RECOMMENDED SERVICE BULLETIN

RSB 40-047/4

RSB D4-052/4

„REPLACEMENT OF RH AILERON AND GMU 44 RELOCATION“

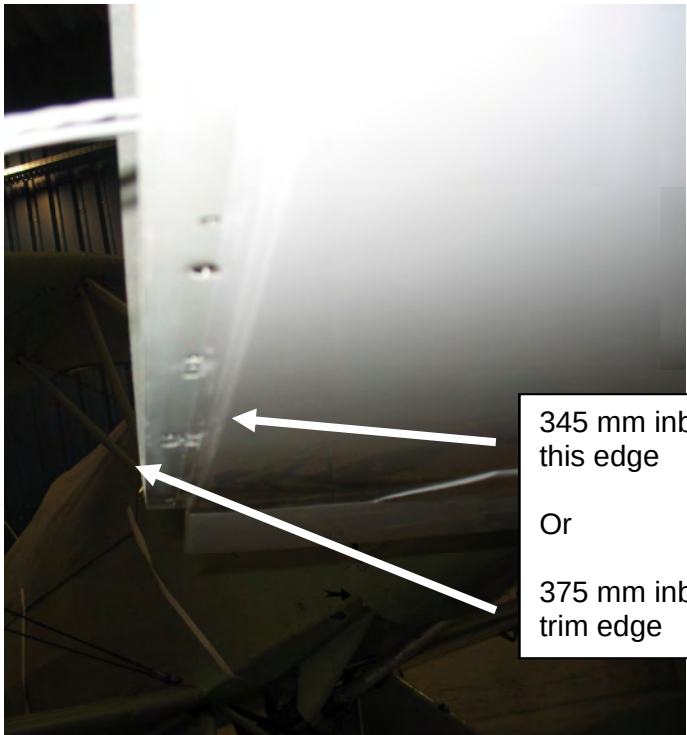
Replacement of RH aileron:

Qty	Description	Part Number
1	Right hand aileron	DA4-5762-00-00_1
5	Spring pin	DIN1481-1.5X10-A2
1	Hexagon nut, self locking	DIN985-M6-A2
4	Screws	DIN 7971-C3.5x13-A2

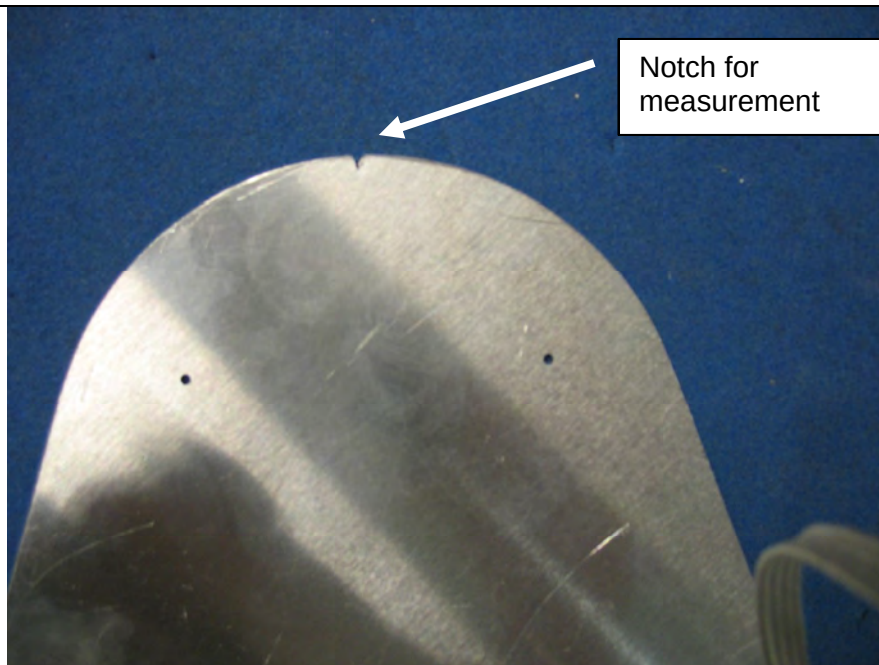
6.	Remove the GMU 44 magnetometer in accordance with the instructions given in the AMM.
7.	Replace the 4 screws of the strain relief of the GMU 44 connector and harness connector with DIN 7971-C3.5x13-A2 screws.
8.	Remove RH wing-tip.
9.	Mark drillholes using marking template D4D-5741-00-SO. Refer to Drawing D4D-5741-00-00x02 and photos. Note: Use notch on Template for measuring. Caution: You must not use marking template as a drilling template!  345 mm inboard of this edge Or 375 mm inboard of trim edge

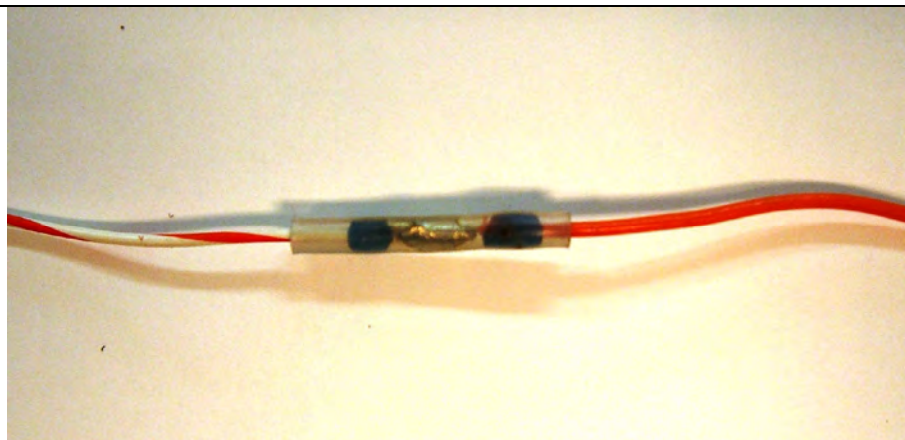
10. Drill 3 times 7.1mm hole (0.281 inch) through outer laminate of lower shell on marked positions.
11. Remove residual foam to allow the bushing fitting flush into the drillhole.
12. Try fit bushings.
13. Bond in bushings with Terostat MS 9380 and allow for curing.

D4D-5741-00-00-01				Zeichnung Nr.:	D4D-5741-00-00x02			
Nr.	Blatt	OS	Bohm	Diam	Name	Kreuzschlitz		Blatt
1	1	1	1	1	1	1		1
TECHNISCHER D4D-5741-00-00-02

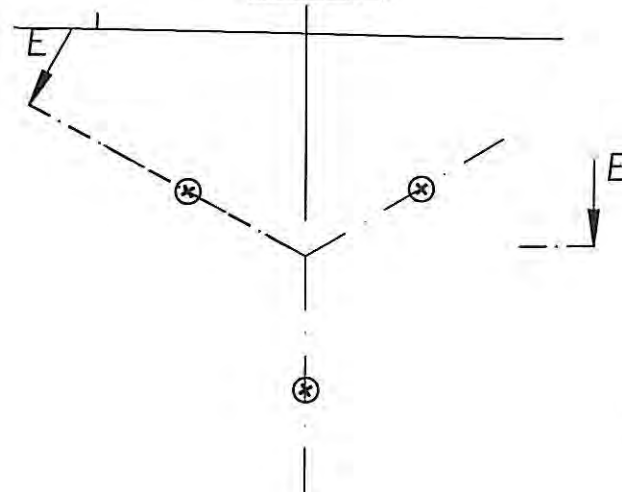
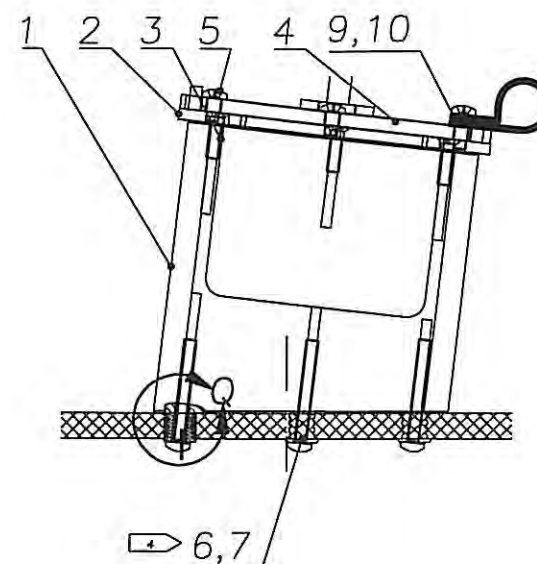
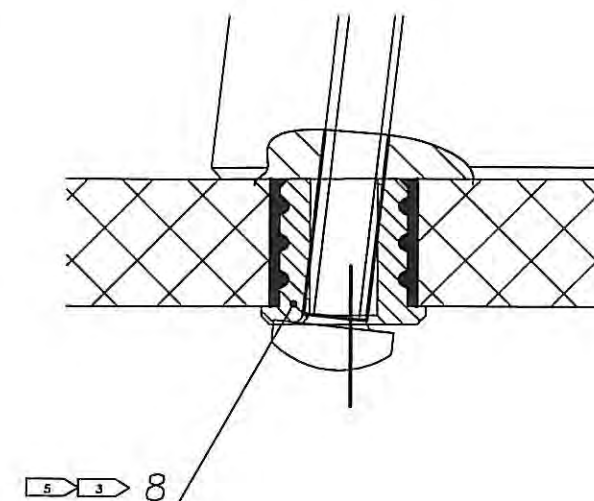
16.	Install clamp 187-7700 using screw MS 35214-25 on magnetometer and clamp harness plug. Refer to drawing D4D-5741-00-00x02.
17.	Secure harness using a tie wrap socket and a tie wrap. Bond base to wing shell using either bonding paste or 5-min-epoxy.

Diese Zeichnung ist nur gültig wenn im Detail R KEIN Wartungsausschnitt vorhanden ist.
This drawing is only valid if there is no access hole in Detail R
-

Für das Markieren der Bohrungsposition ist die Schablone D40-5741-00-SO zu verwenden.
To mark the drillhole position use template D40-5741-00-SO
-

Inneres Laminat der Sandwich-Konstruktion stehen lassen nur Loch für Schraube bohren
keep inner laminate of sandwich-structure drill only hole for screw
-

Mit Loctite 262 sichern
Secure with Loctite 262
-

Buchse mit Terostat MS 9380
Band in bushing with Terostat MS 9380
